PAGEWOOD GREEN STAGE 2 MASTER PLAN
PLANNING PROPOSAL

PEER REVIEW

Prepared for Bayside Council by

In July 2017 Hill Thalys was engaged by Bayside Council to assess Meriton's revised master plan for Pagewood Green Stage 2 (referred to in this document as "**Revised Proposal**"). This follows earlier work undertaken by Hill Thalys to produce a comprehensive Urban Design Study for the site in 2016.

4.2 MERITON REVISED PROPOSAL

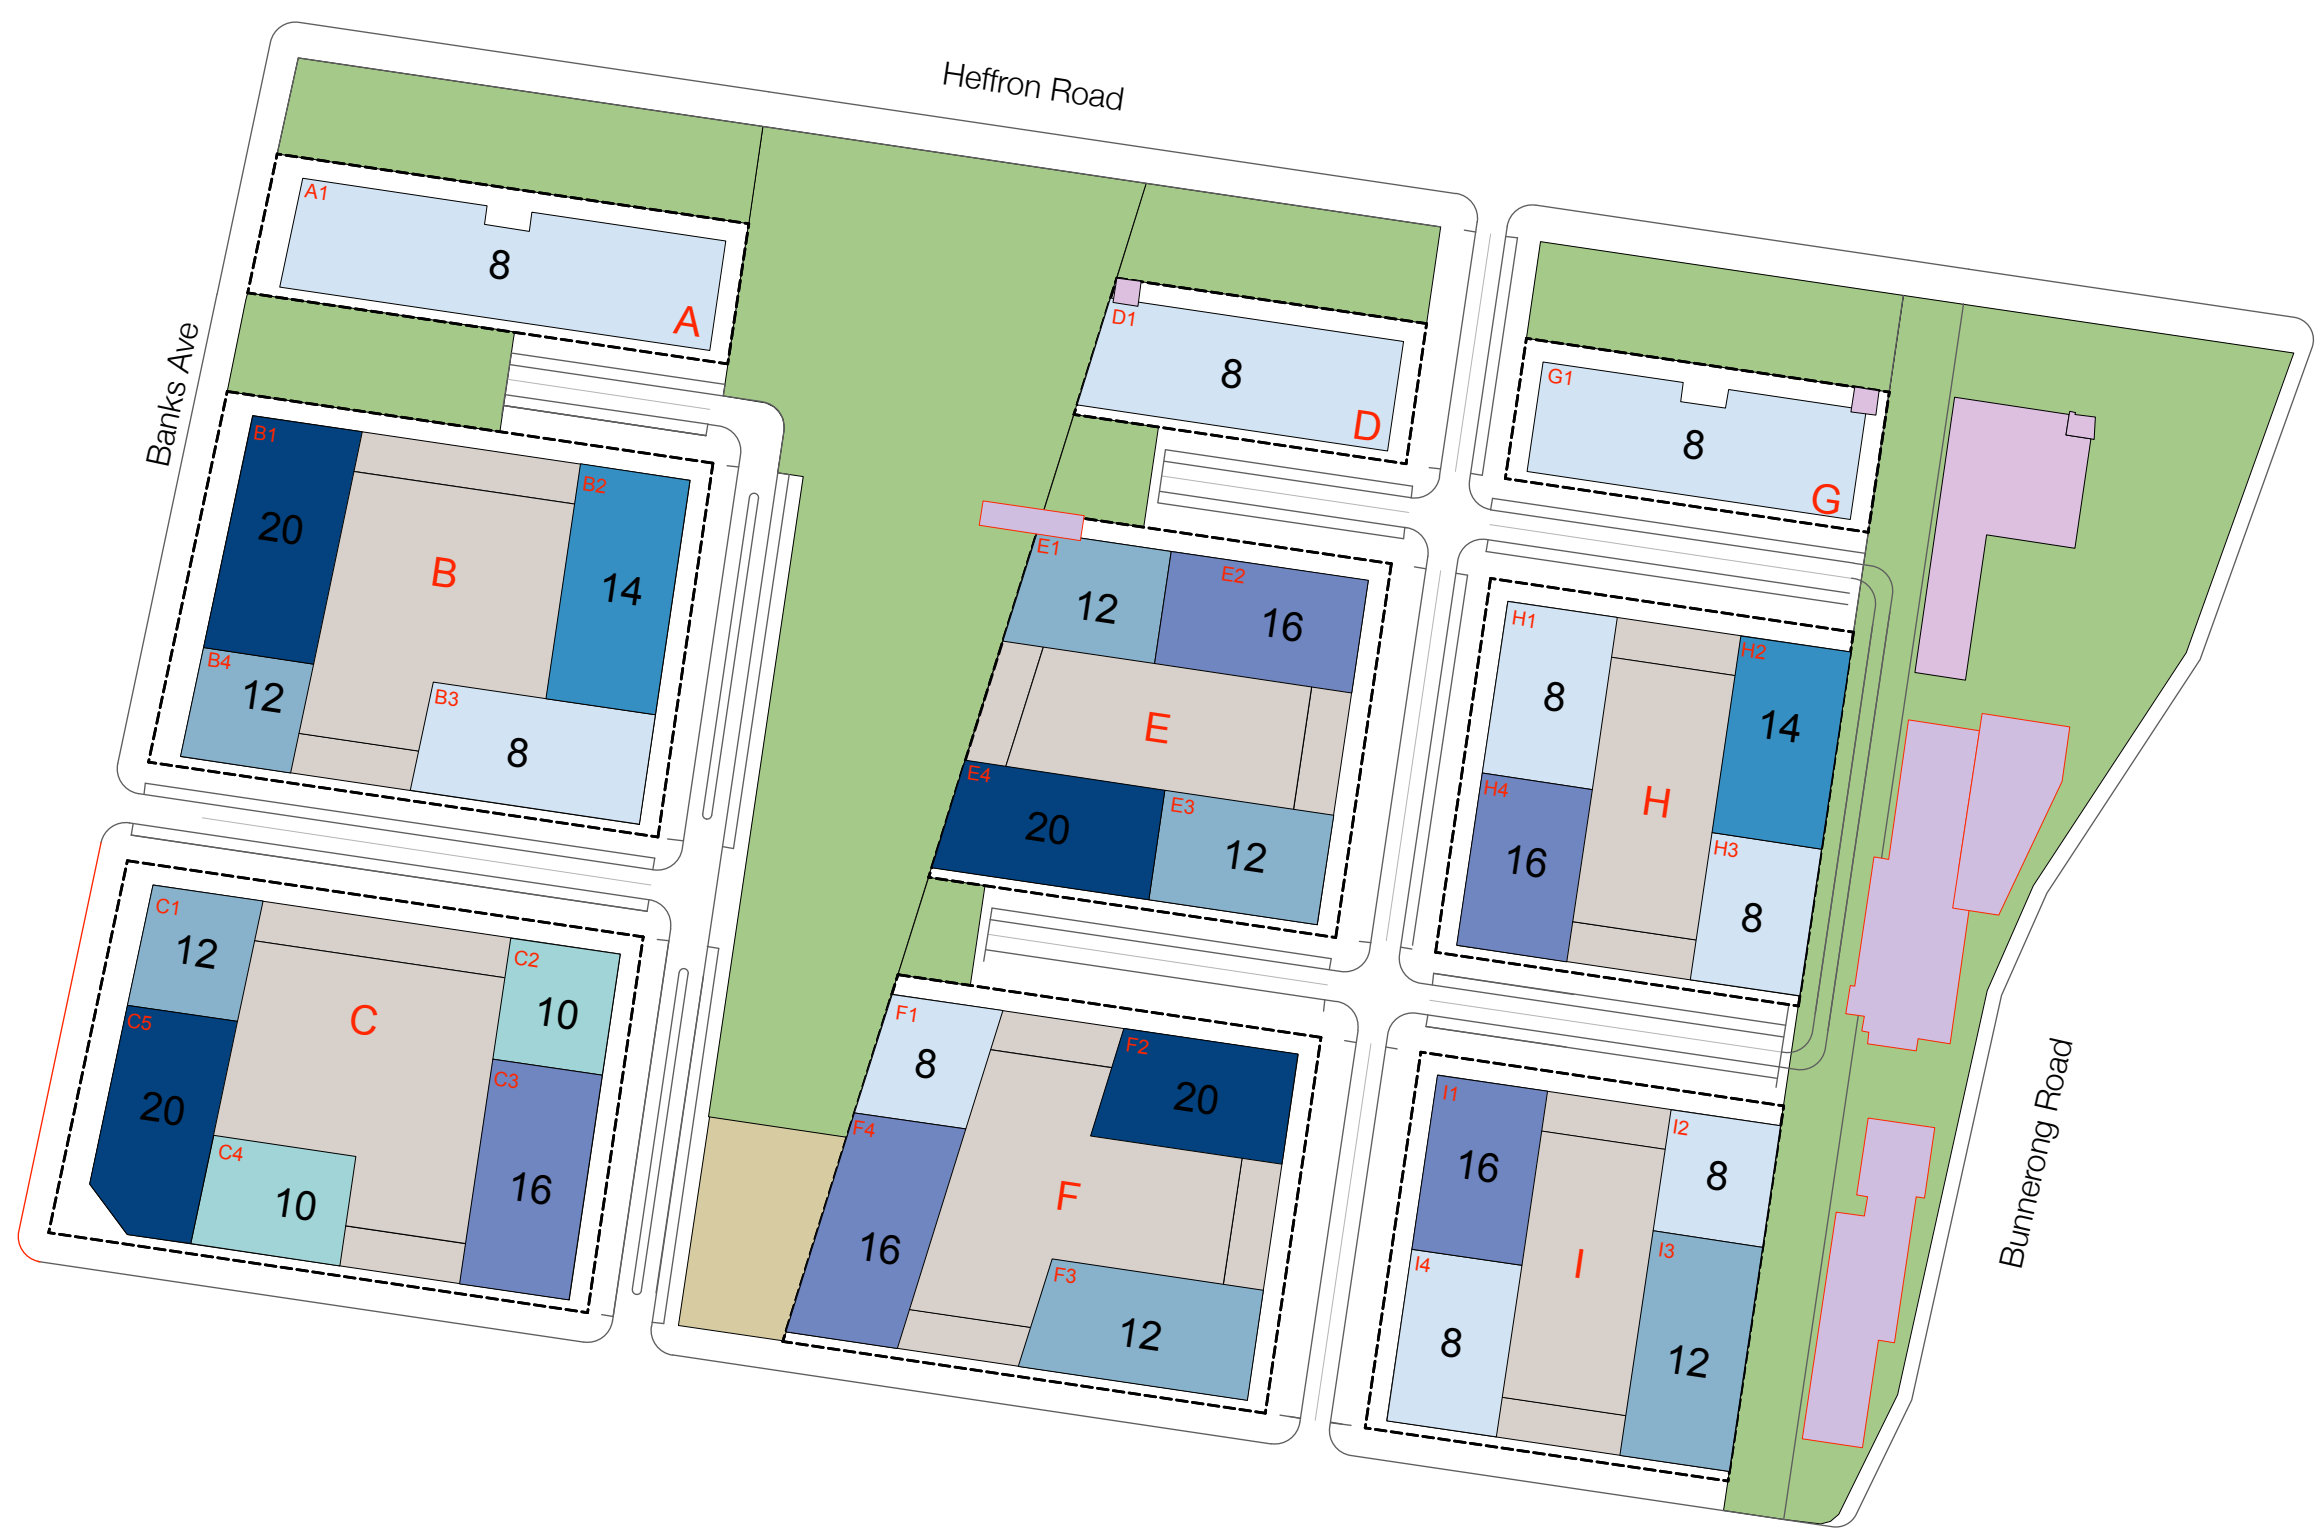
- The disconnection of the street network - resulting in a number of cul-de-sacs and building frontages without a street or lane;
- The relocation of the wedge park to the western half of the site, resulting in the majority of urban blocks being located closer to Bunnerong Road;
- The re-orientation of the wedge park from primarily north to north east with resultant overshadowing (detailed analysis in further pages);
- The inclusion of above-ground podium parking, resulting in the loss of courtyards with deepsoil and an increase in bulk and diminished ability to provide through-block links;
- Clustering of similarly proportioned built form which may result in significant overshadowing and an inability to meet SEPP65 and Apartment Design Guide benchmarks.

Whilst the Revised Proposal provides a number of positive changes, several key strategies should be further revised to optimise and provide a best-practice urban exemplar. Please see section B for recommendations subsequent to the comparative analysis contained in the following pages.

4.3 PUBLIC STREET NETWORK

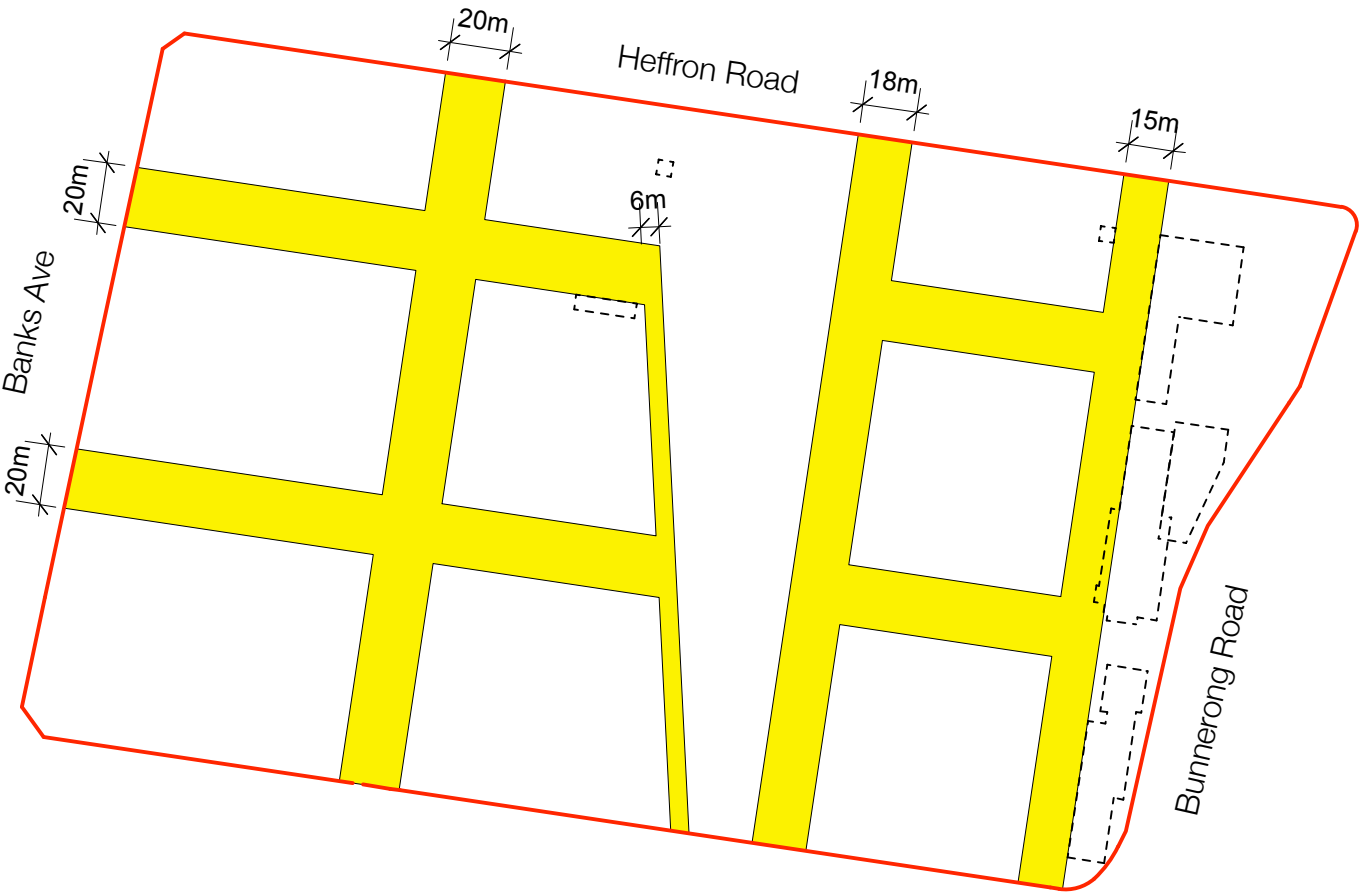
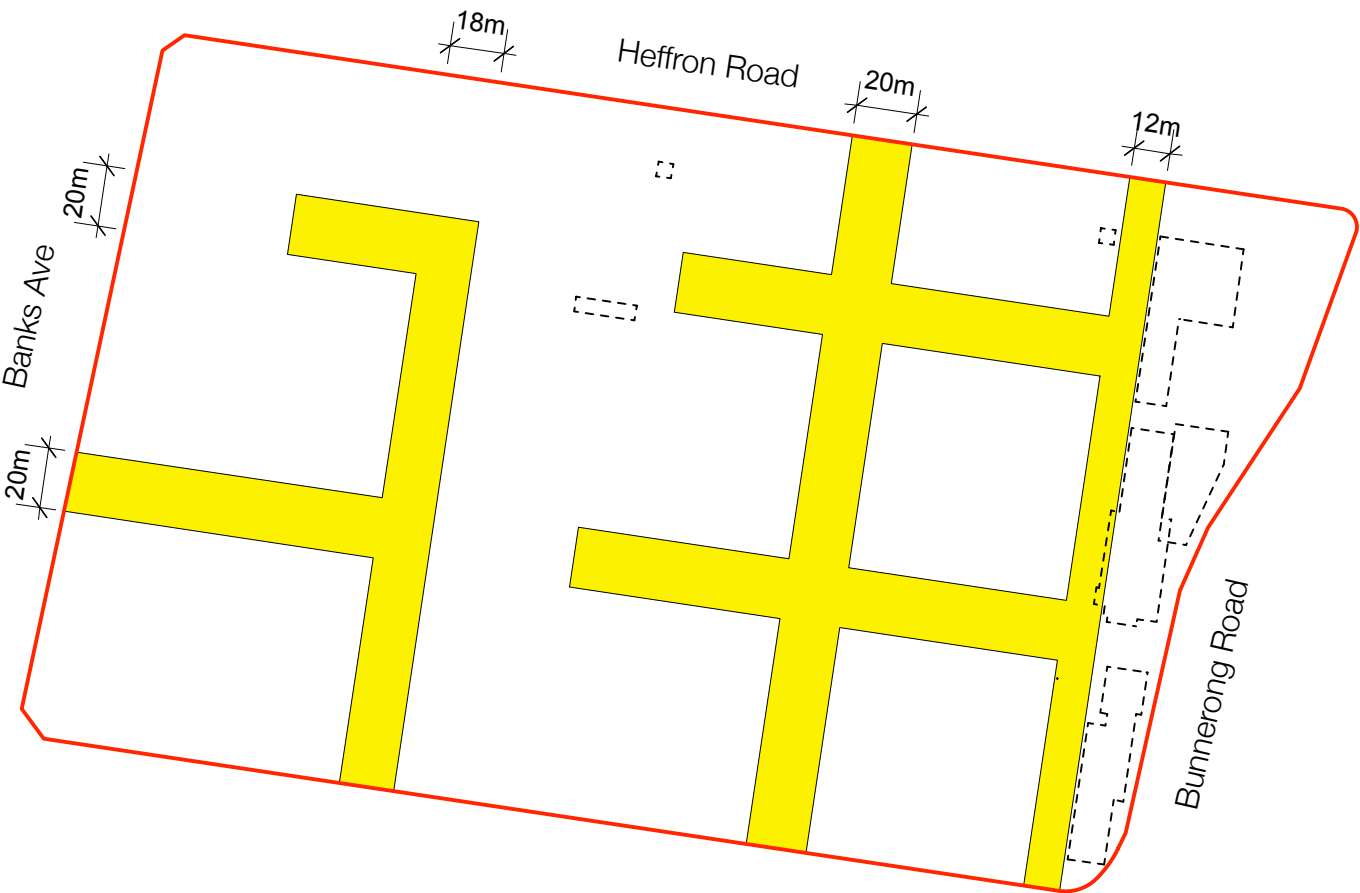
The Revised proposal provides an incomplete street network which leaves several blocks without adequate street address, particularly along the eastern edge of the central park.

Street and lane reservations should be provided along each block boundary, but may take the form of a share-way or traffic limited environment to suit the desired access in, out and around the site.

The unfinished nature of the street network is unsupportable.

4.4 PARKS AND OPEN SPACE

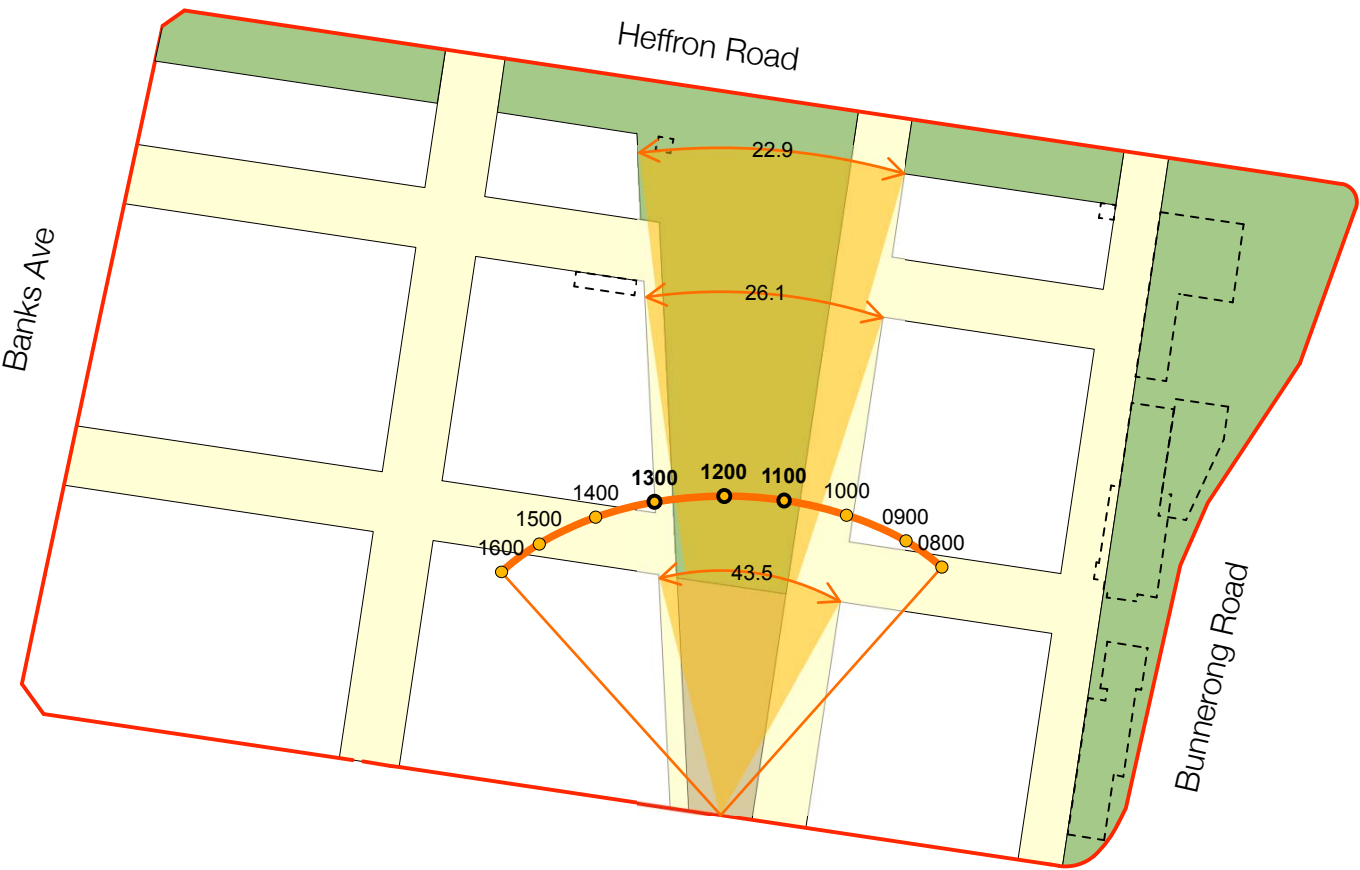
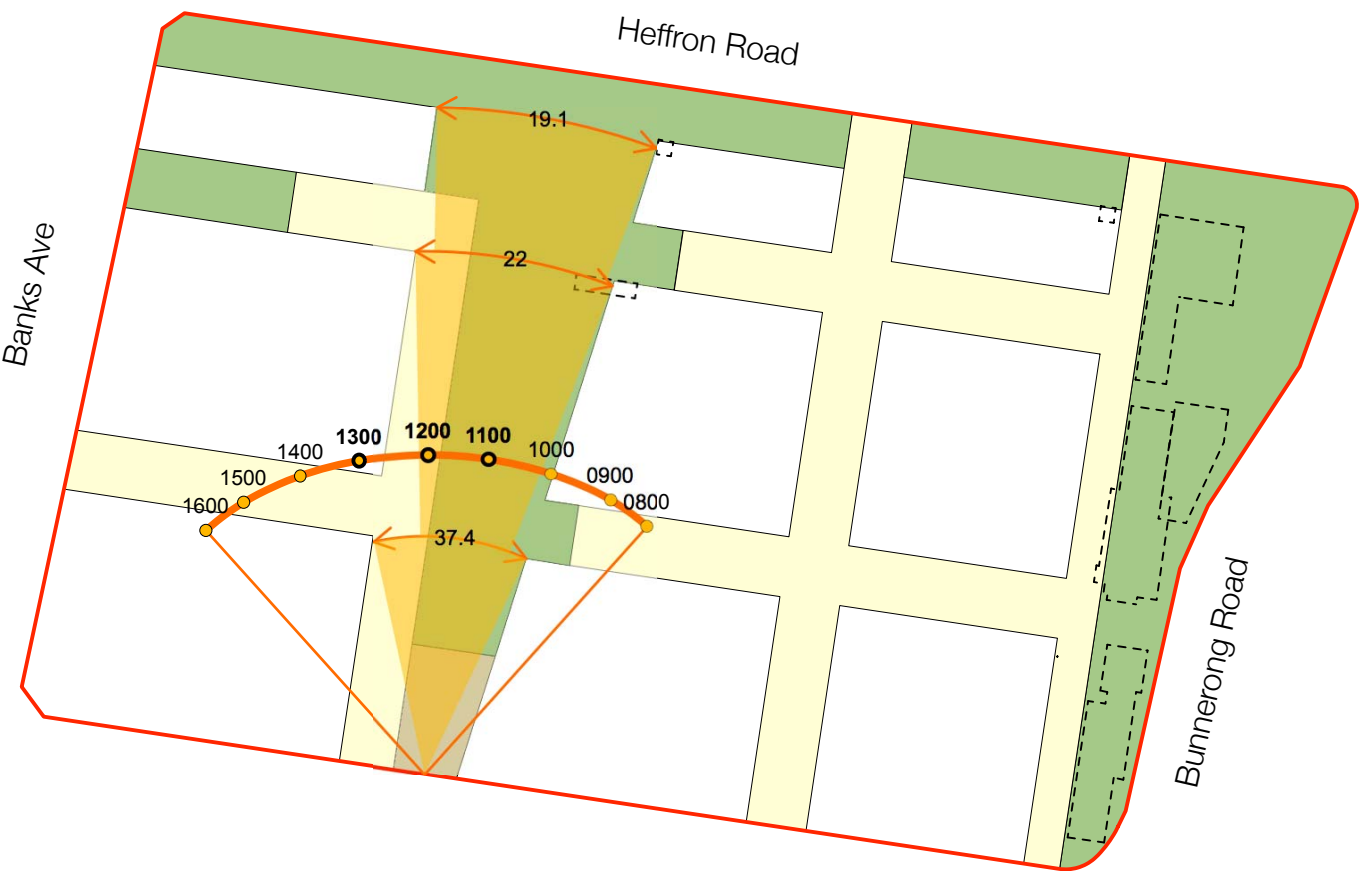
The Revised Proposal provides for a wedge park that pulls open space deep into the site. The change in orientation from the Draft Council Master Plan provides less solar access in total due to its rotation further east of north (up to 14% less).

Importantly the more easterly orientation reduces the potential solar access to open spaces at the critical time between 11am and 1pm.

The definition and dedication of streets and open space in the Revised Proposal is confused. The deletion of street portions converted to pocket park detracts and confuses from the primary open space and increases the proportion of parks at the expense of streets.
